**AN AMENDMENT TO THE
MASTER DRAINAGE DEVELOPMENT PLAN
FOR
WATERVIEW**

WATERVIEW NORTH

EL PASO COUNTY, COLORADO

October 2020

Proposed Pond A

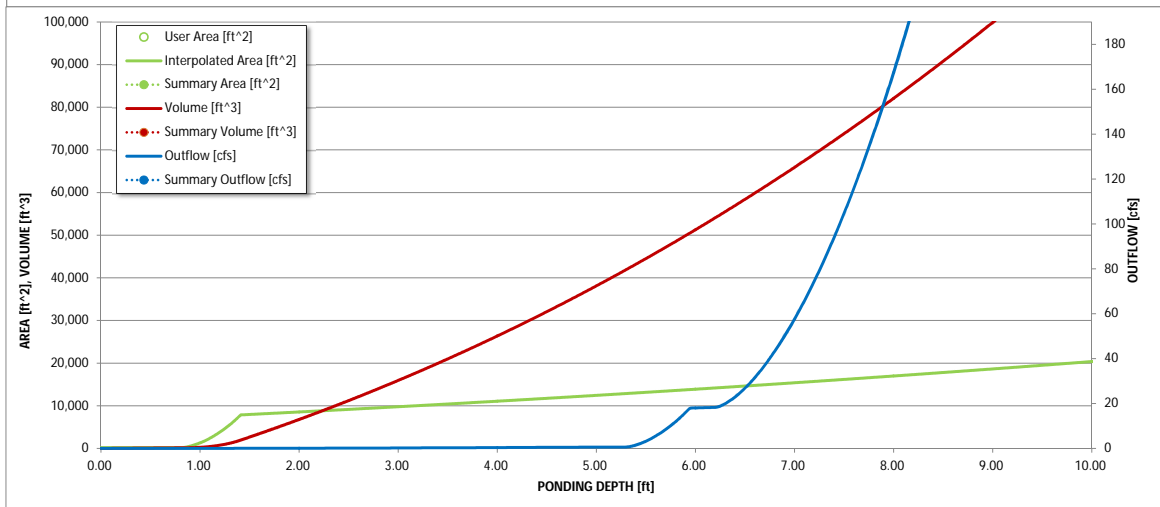
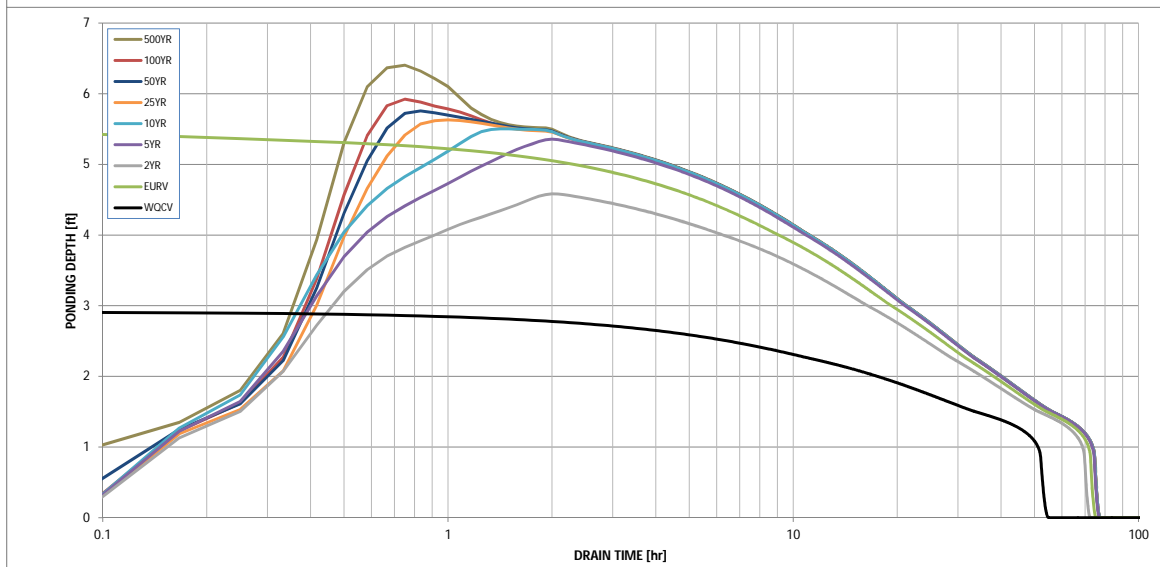
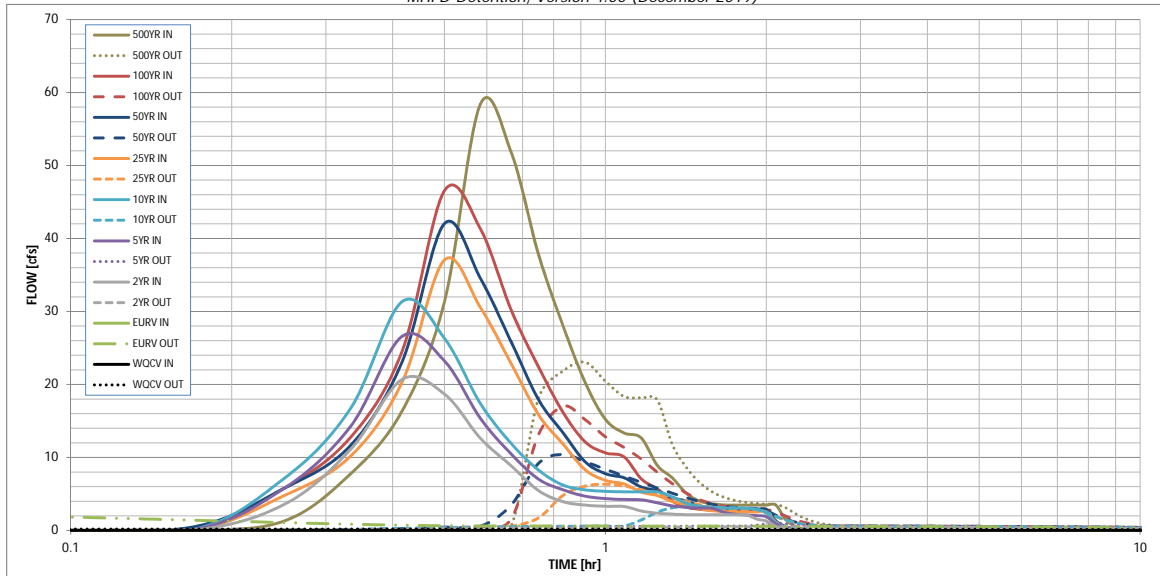
FYI: Final pond design will need this

Rating Curve Plot for Crossing: BRADLEY XING DUAL 42 CMP

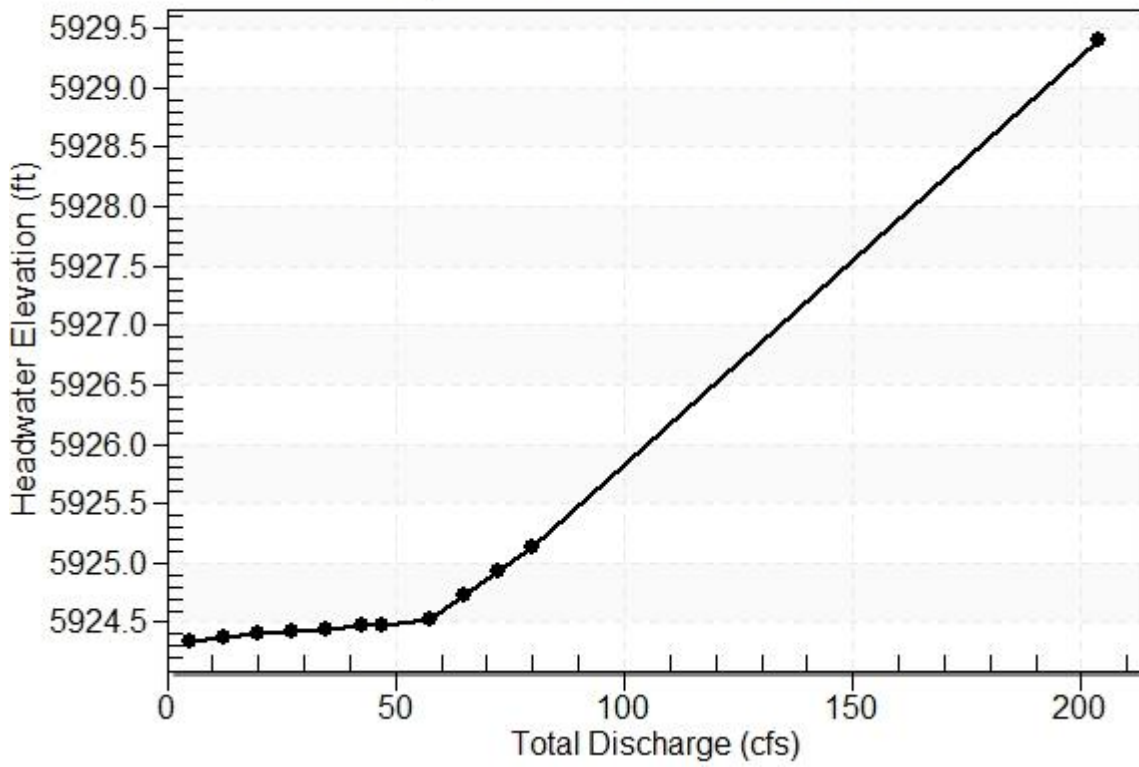
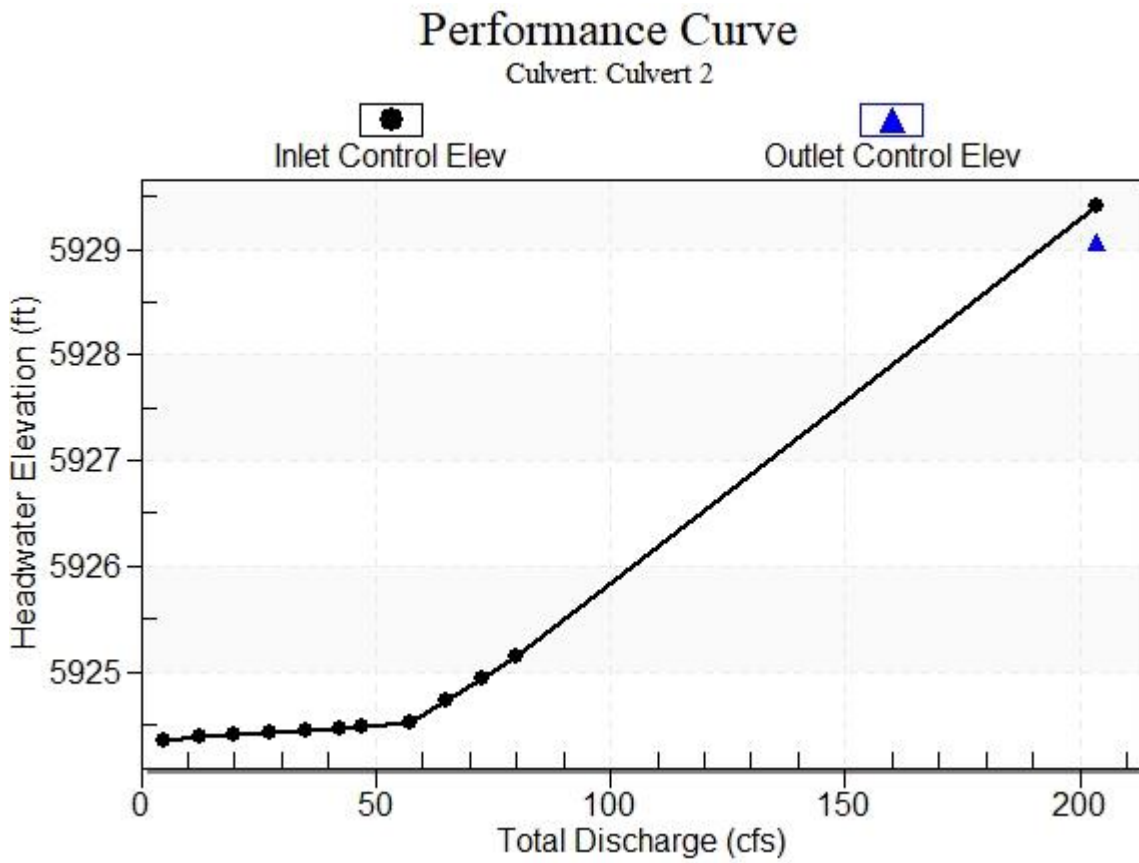
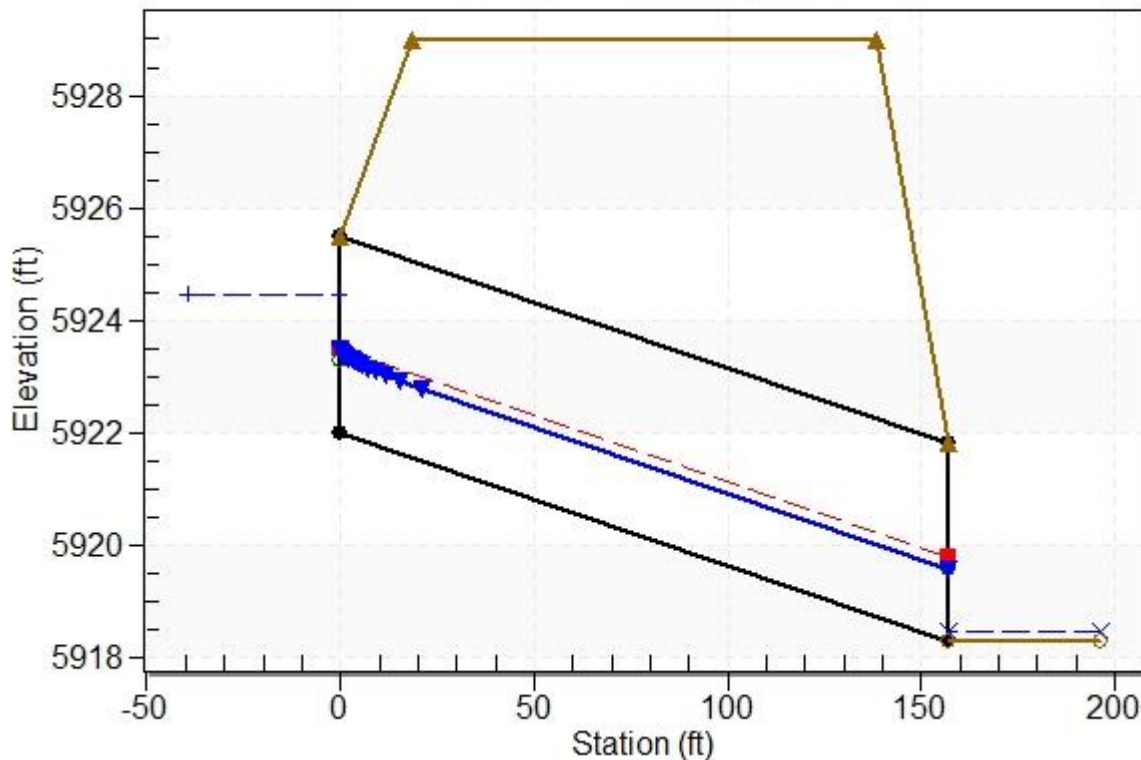
Revise calculation. Per the narrative one is being plugged and the other is reduced.
